Confidential	Product Development Design Change Request 产品开发设计变更请求		Version 15 Effective date: 2025-12-01th
	Customer project Name/ 客户项目名称: JIM-4JJ		Design Change Request No. 25_128
Sample status / 样件状态: ☐ A Sample ☐ B Sample ☐ C Sample ☒ D Sample			
Change part&product Name/更改零部件产品的名称(简要描述) DOC DPF :F01ZH003EA-00 SCR: F01ZH003EB-00 DPF BRACKET:F01Z5017P5-05			
Reason of changes/更改理由 (简要描述): DPF 出气法兰, 客户装上双头螺柱后, 有密封垫片, 安装不上, 的风险, 需要增加 对出气法兰螺母的位置检测 SCR 客户要求 在尾管处增加纸质标签 侧支架 客户要求 更改客户料号			
Change from/变更来源:			
Customer request / 客户要求 ☒		Supplier request / 供应商请求 ☐	Design optimization / 设计优化 ☐
Correction / 更正(错误) ☐		Other / 其他 ☐ ()	
Change inform to/变更通知人: Zhang Shengchang,Zhang Hanquan,Shen Weibo, Li Yicen, Fang Jiayan, Yin Kangzhuang Yang Guangtuo,Jia Kebin, Luo jing, Lu Qingsong,Xie Youfu			
Whether this change impact others component or product 此变更是否影响到其他部件和产品: ☐ yes/是 ☒ no/否			
If impact others product, Whether others projects&product change or not? 如果影响, 别的部件和产品是否也需要同时变更?

PDEC R25-128 (4JJ1-D 样件)

PDEC R 25-128

ENG-CV

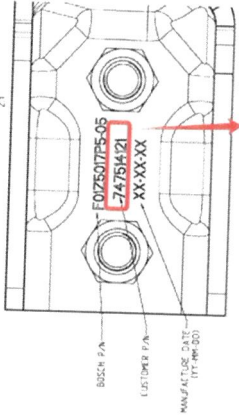
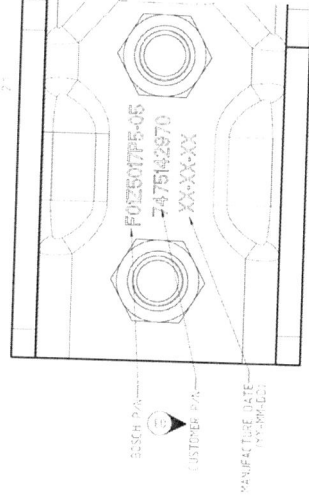
零件号	零件名称	Project	样件阶段	变更来源
	F01Z5017NL-05	DOC+SDPF WELDING	JIE-4JJ	D	BOSCH/Customer
	变更前		变更后		
	F01Z5017NL-03				
变更描述			增加新的检测方法: 拧入螺栓后(螺栓长度同客户螺栓), 需100%过客户垫片		
变更原因			增加新的检测方法;		
风险点(影响)			无		
验证方法			无

PDECR 25-128

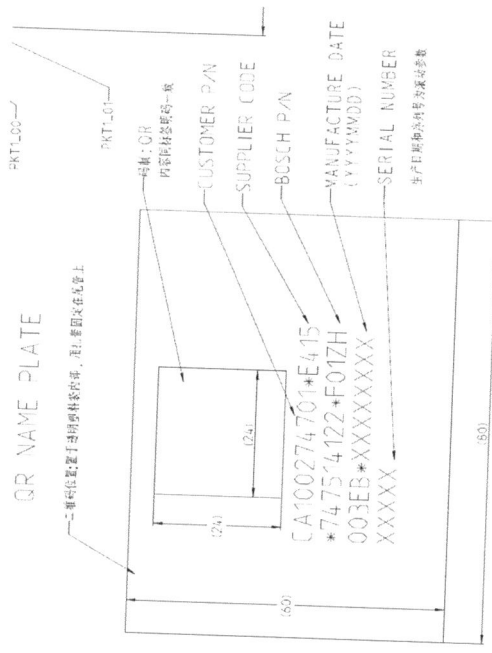
零件号		零件名称	Project	样件阶段	变更来源
	F01ZH003EA-00					
	变更前					
变更描述						
			料号更改，模型无变更 由F01ZH003EA-03改为F01ZH003EA-00			
变更原因			料号更改			
风险点（影响）			无			
验证方法			无
